**ADDENDUM
NO. 3**

June 9, 2023

**LAKE STREET ELEMENTARY SCHOOL ADDITIONS, RENOVATIONS,
AND RELATED WORK
Crown Point, IN 46307**

Addendum Three (AD.03) to the drawings and specifications prepared by Gibraltar Design for **Lake Street Elementary School Improvements** for Crown Point Community School Corporation, Crown Point, Indiana.

3
A-861

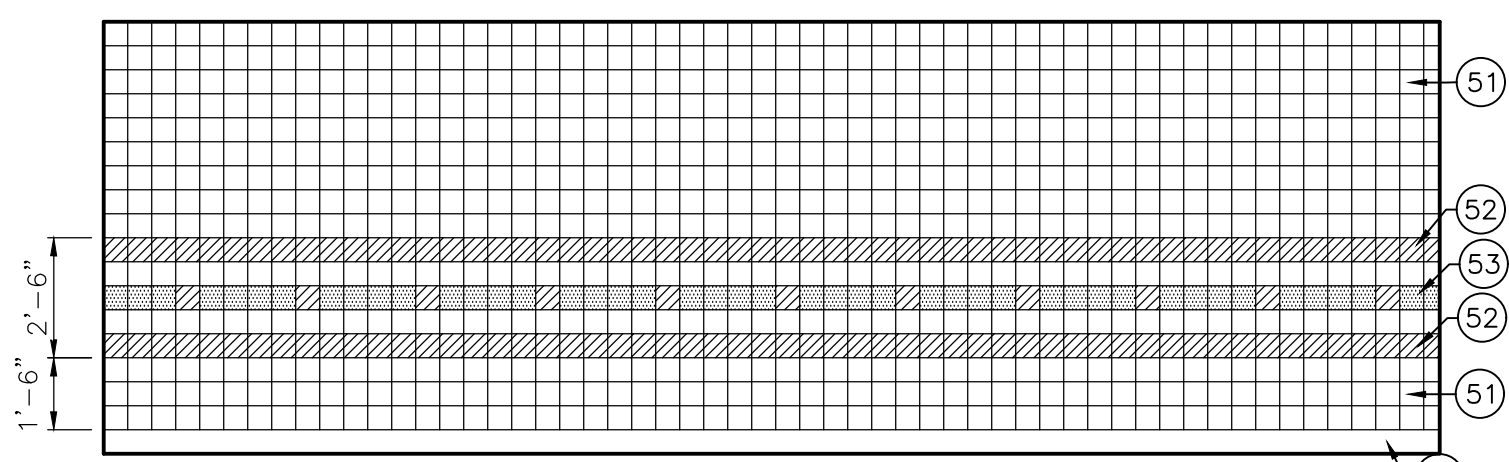
**6. Sheet A-861**

1. Revised elevation 1/A-861
2. Revised elevation 3/A-861

© GIBRALTAR DESIGN SHEET
MV103

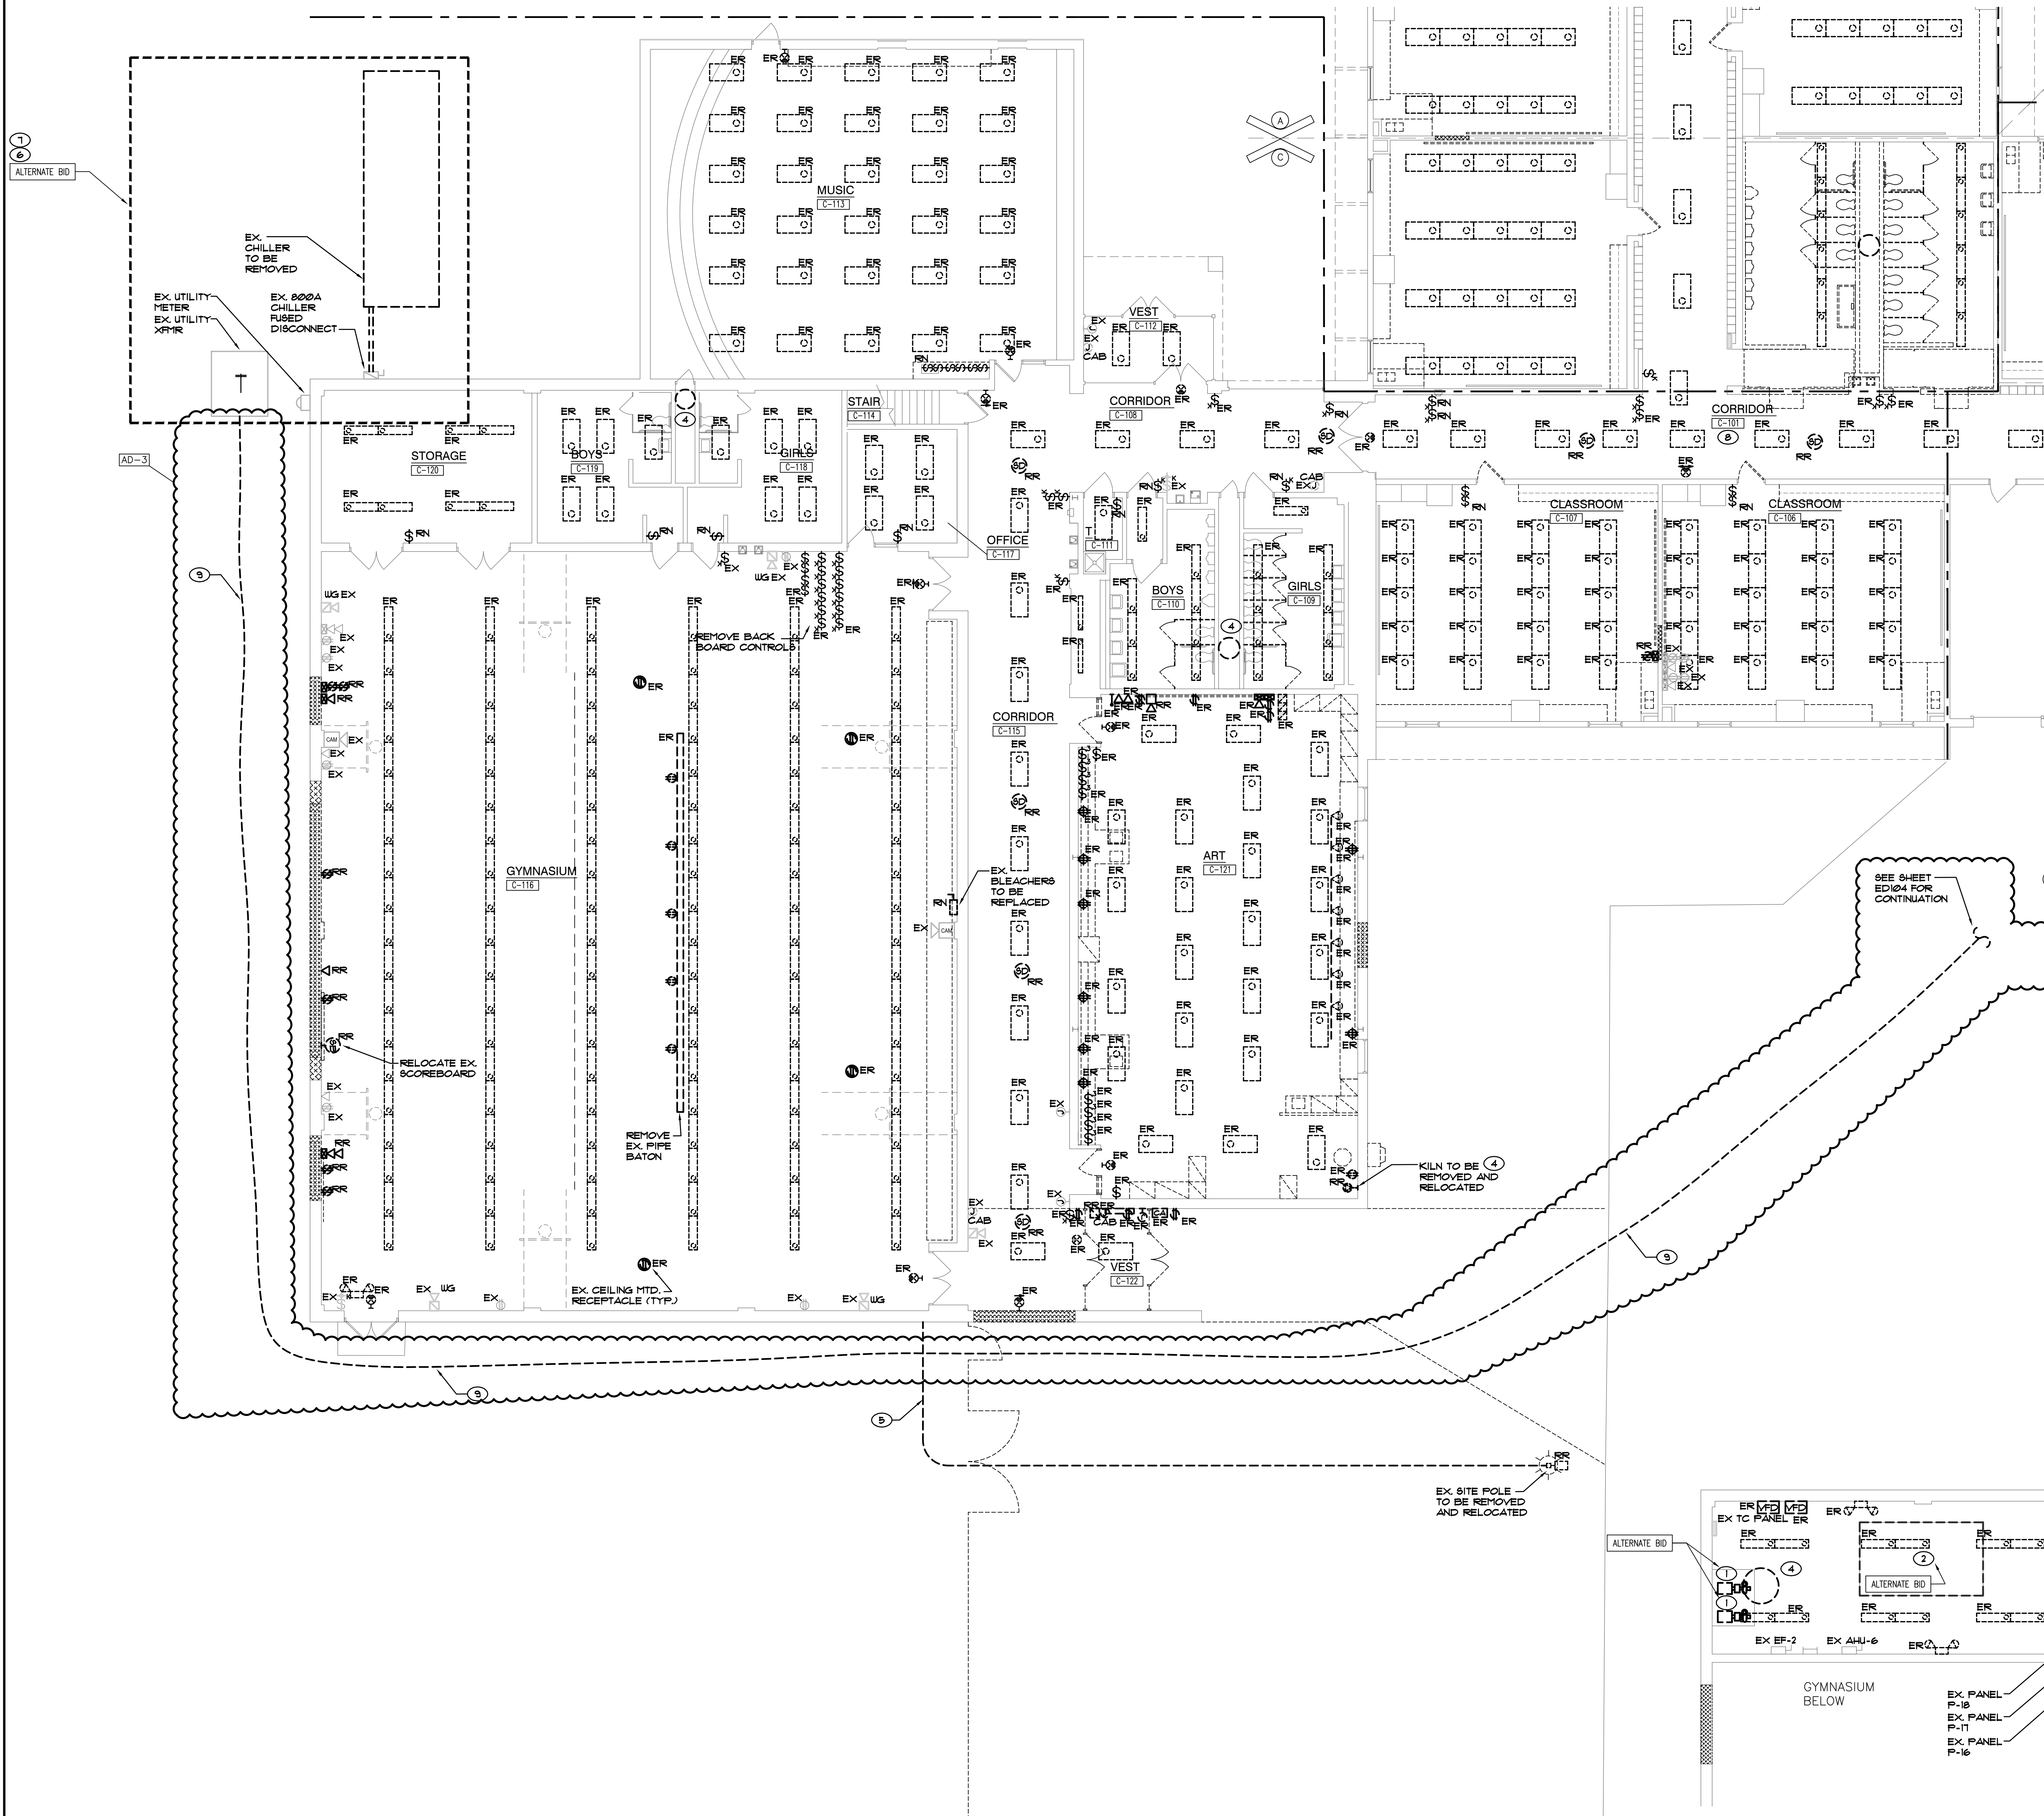
8. Sheet MV-103

1. Added note for wall cap to be painted – color by architect

GIBRALTAR DESIGN SHEET
ED104

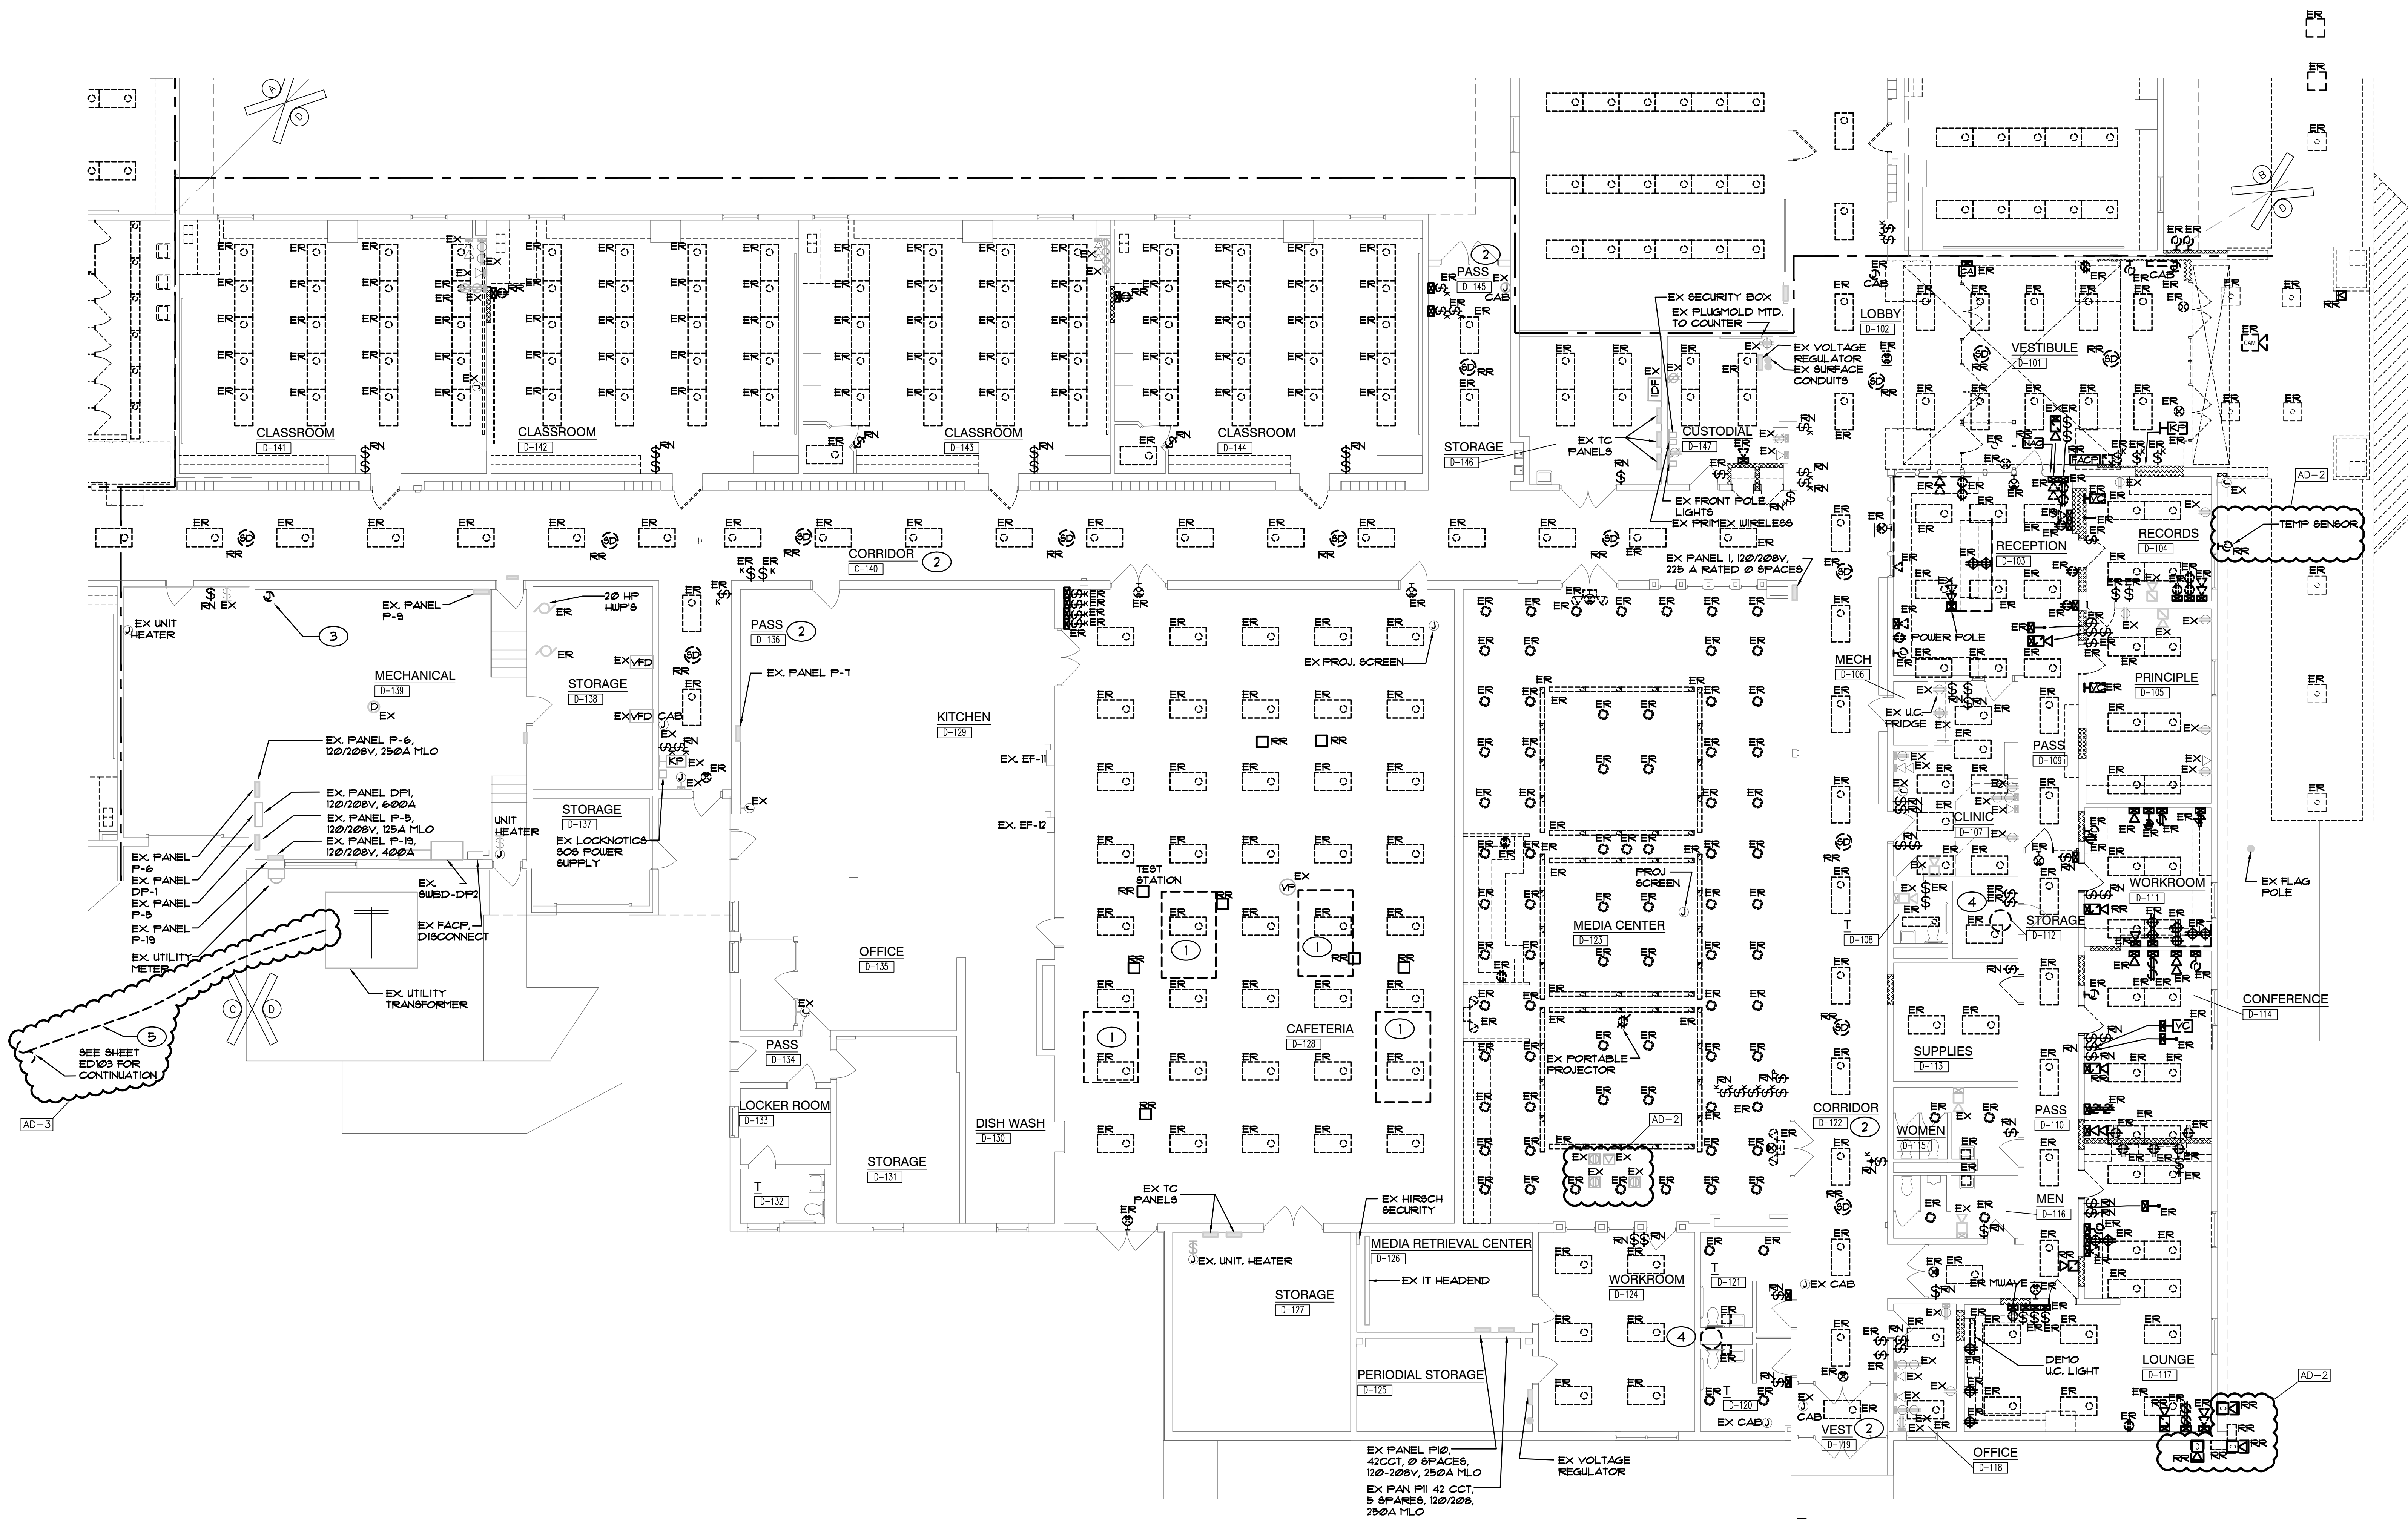
11. Sheet ED-104

1. Added sheet note.
2. Added primary feeder to be re-routed.
